11.6 Roseburn Park Walk and Cycle Improvements Consultation Summary Report

March 2017

This report summarises the consultation exercise undertaken during the preliminary design stage of walking and cycling improvements to QuietRoute 8; Roseburn Park.

Figure 1 Roseburn Park proposals

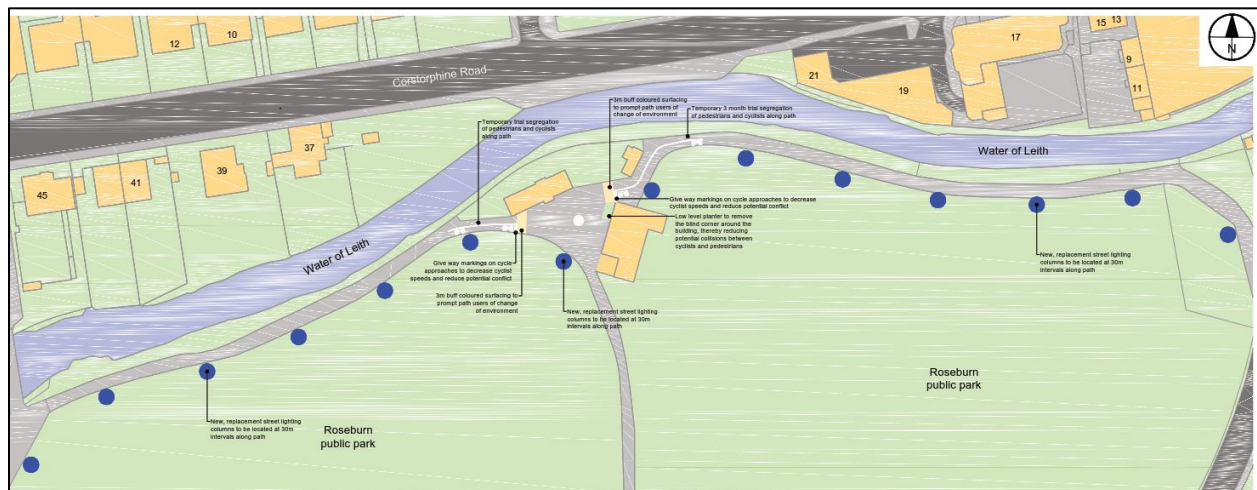
36	Support		
33	Support		
59	Neither support or oppose	The idea of delineating separate space for bikes and those walking is good in principal, but I doubt the proposed design will make much difference with such short lengths of paint. I am also unconvinced of the benefit of installing the tactile paving in this location, as there is no real segregation to remark, and it can feel unsafe to cycle across when wet. I like the idea of the low level planters to reduce conflict at the building corner, but unsure what the white spot in the middle of the junction represents? If it us the intention to turn this into a roundabout, I think that is unsuitable for a shared use path in a park	This is a 3 month trial and we shall evaluate its effectiveness before proposing a permanent solution. The buff surface will take to form of an anti-skid surfacing whether than tactile paving. As such it will less slippery than the rest of the path, even when wet. The white spot represents the existing raised flower bed, which shall be retained.

7	Oppose	While I strongly support improvements, I do not think the detail shown on sheet number 60512201-SKE-C-WP2-11.6-0102 and in the supporting information is an appropriate response. The supporting information states that "Separating sections of the main paths so that people walking use one side and people cycling use the other". My experience of using paths where this type of separation is included is that, in practice, people do not neatly organize themselves into the sections that they are intended to use. I have concerns regarding this as marking out sections in this way also promotes a sense of ownership and priority, which often translates as inappropriate speed. In short, while this approach is recommended in Cycling by Design, my experience is that the proposed separation is designing in conflict as the theory is sound but behaviour does not necessarily align with it. I welcome the intention to trial this approach for 3 months but have concerns that it may become a permanent feature without review. The use of different surfacing materials to reinforce change of environment, particularly at the junctions, is sensible although care should be taken with alignment of tactiles as sheet number 60512201-SKE-C-WP2-11.6-0102 does suggest that these may be positioned at points where cyclists are changing direction, increasing the likelihood of falls, particularly in less experienced riders. Careful consideration to alignment will be required when these are installed. On a more general point regarding surfacing, the path surface through the park requires attention in places and I hope that this is within the scope of the improvement works.	This is a 3 month trial and we shall evaluate its effectiveness before proposing a permanent solution. However, the support indicated from this consultation suggests the proposal is appropriate. Where paths are segregated, such as in the Meadows, we tend to find that interactions between path users is improved. The buff surface will take to form of an anti-skid surfacing whether than tactile paving. As such it will less slippery than the rest of the path, even when wet.
